PLANNING

Job
 1A COMMUNITY CENTRE
 1A Rosebery Avenue
 London EC1R 4SR

Drawing Title
 Rear Elevations Proposed

Laystall Street Elevation Proposed

Drawing No.	Rev.
765 PL (0) 21	H

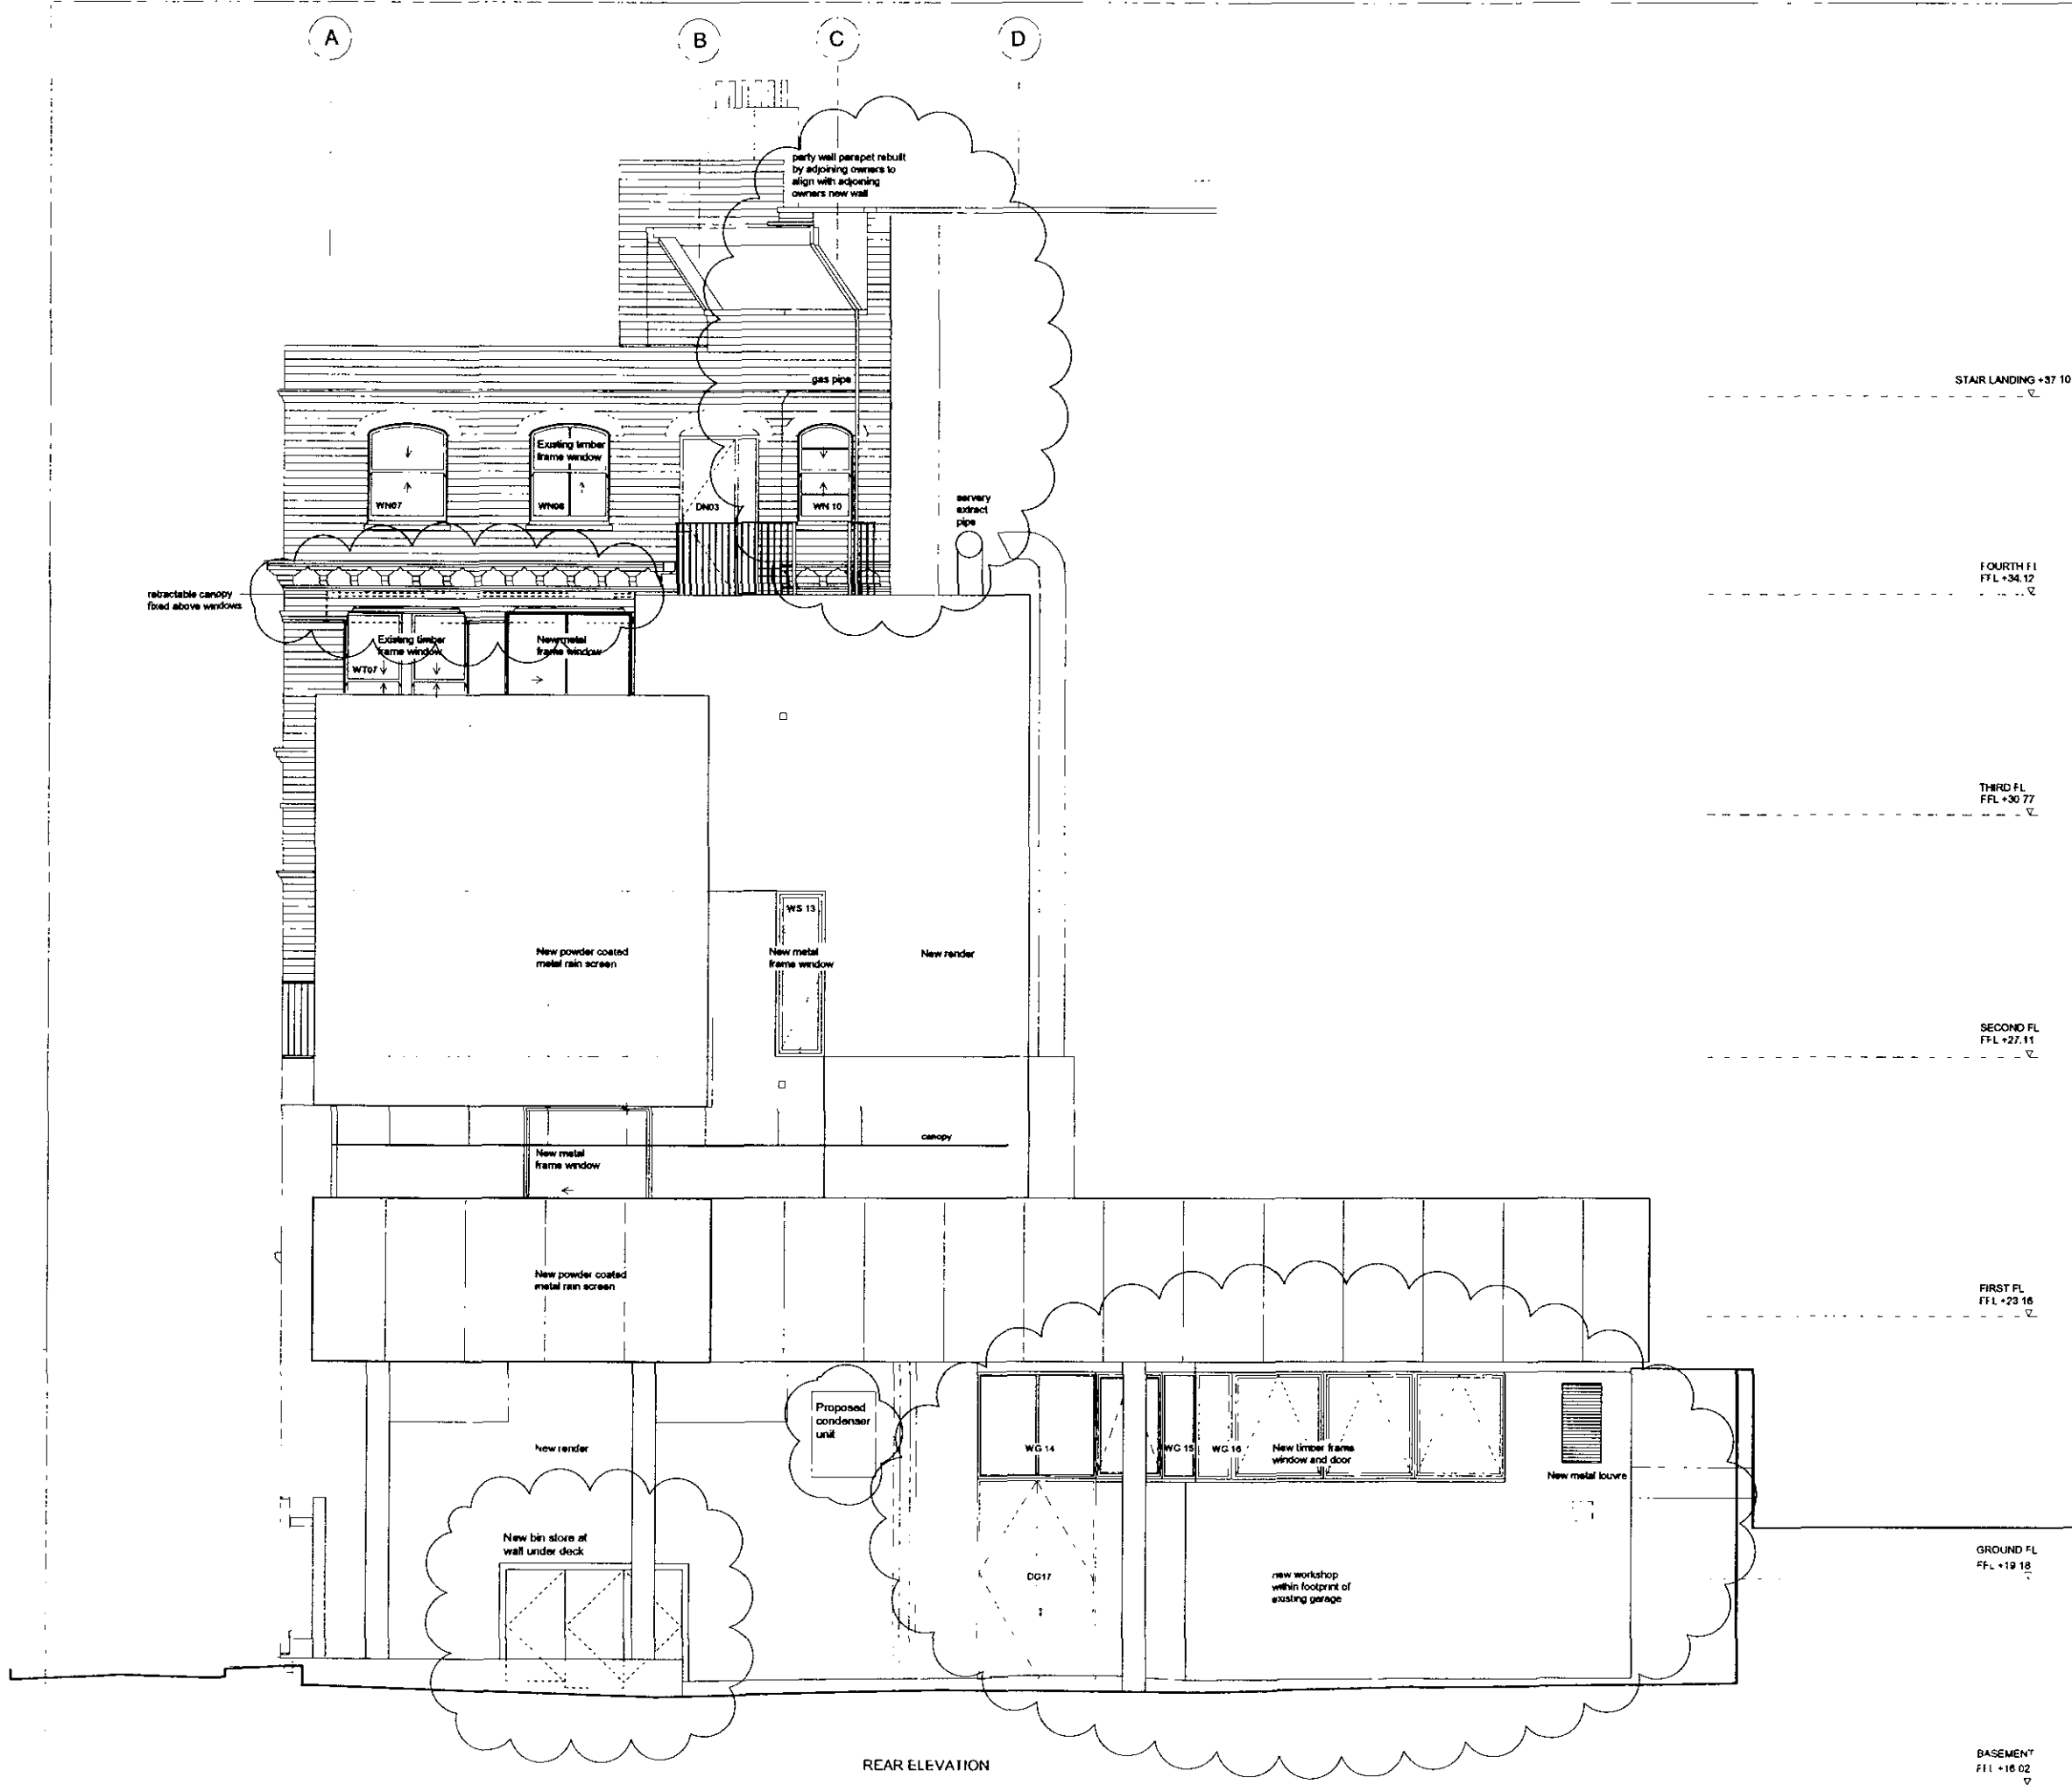
H	06 03 06	SJ	New playdeck extended with new workshop under, within footprint of demolished garage. Extract duct to severy added. Gas pipe added. Retractable canopy added above Third FL playdeck. Condenser unit added below First FL Playdeck. Party wall at roof level amended by adjoining owner.
G	Nov 2005		Extg garage retained and refurbished, existing plant removed, new plant added to garage roof, new playdeck reduced in area. Canopy added at first floor level. Binstore added. New window at second floor omitted. New window at third floor added.
F	Oct 2005	pr	Extg garage retained & refurbished. new playdeck reduced in area.

Drg No. 765 PL (0) 22
 Rev L

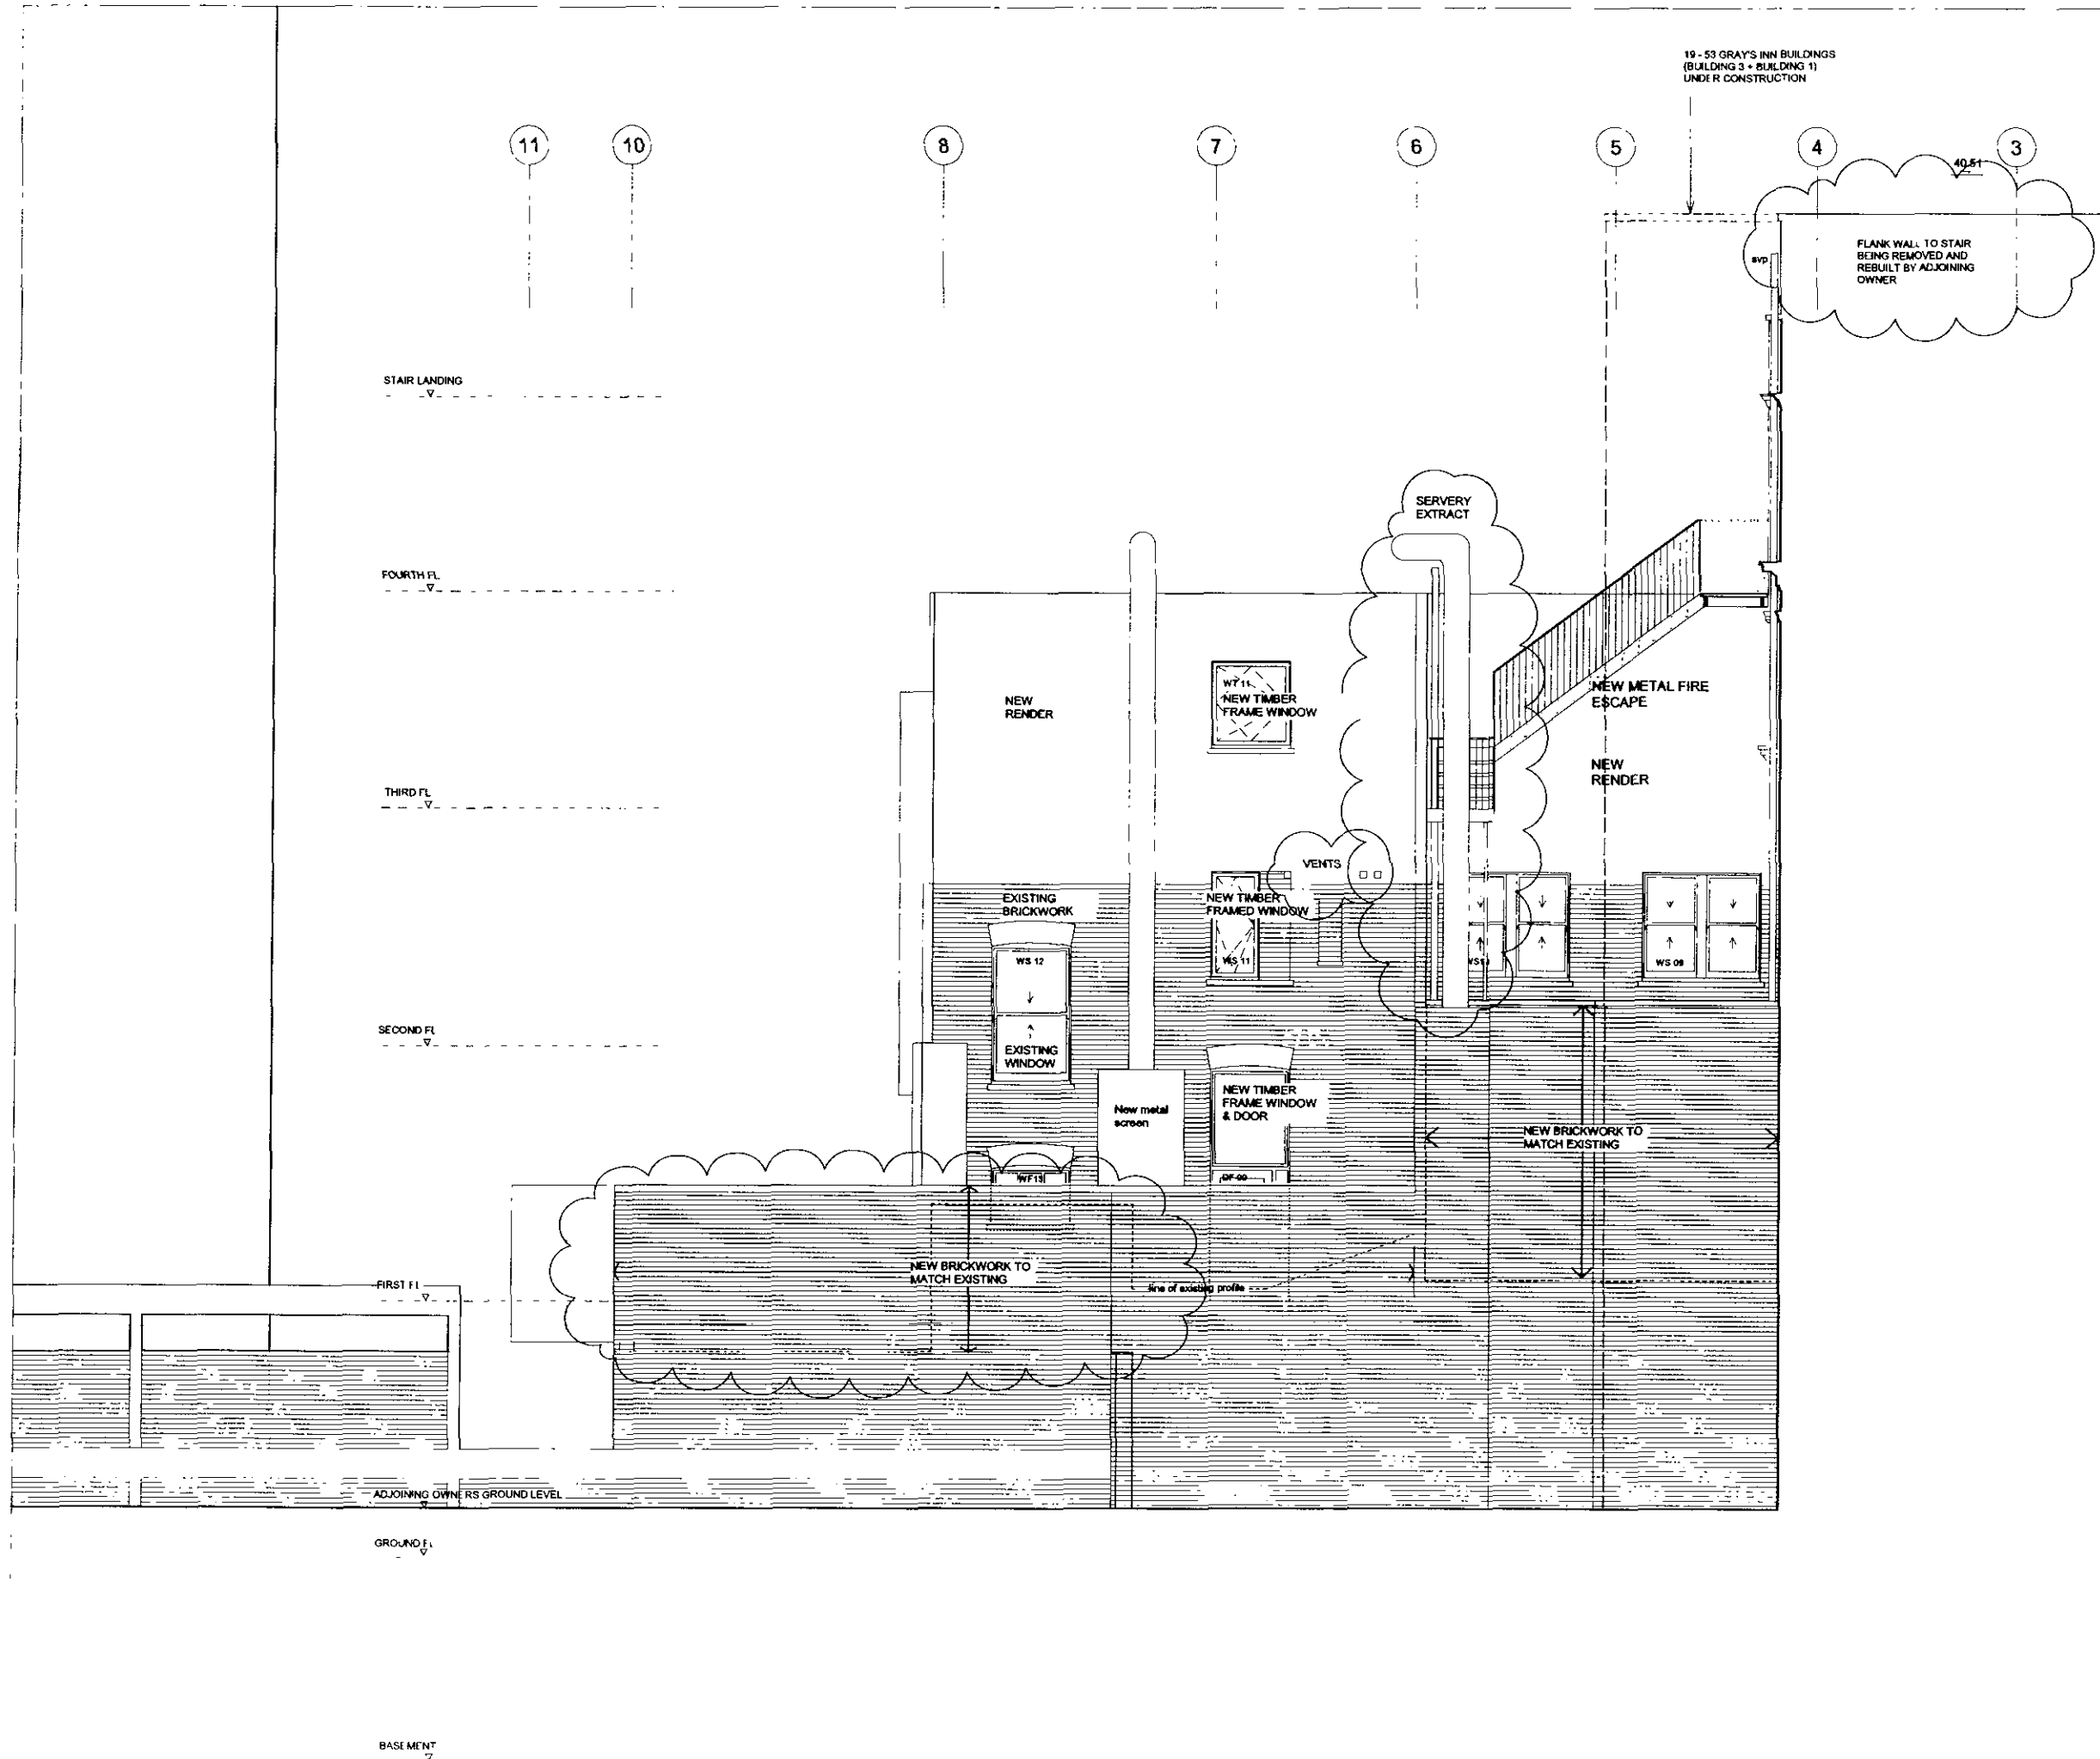
L 08.03.06 SJ New metal louvers shown within WBS01 & 2 basement windows. Transoms added to basement windows. Retractable canopy added above Third Fl. playdeck. Party wall parapet rebuilt by adjoining owners to align with adjoining owners new wall.
 K 16.11.05 Projection at 2nd and 3rd floor level reduced. Canopy added at first floor level. Fourth floor stair extension omitted. Existing fire escape removed and new external fire escape added.
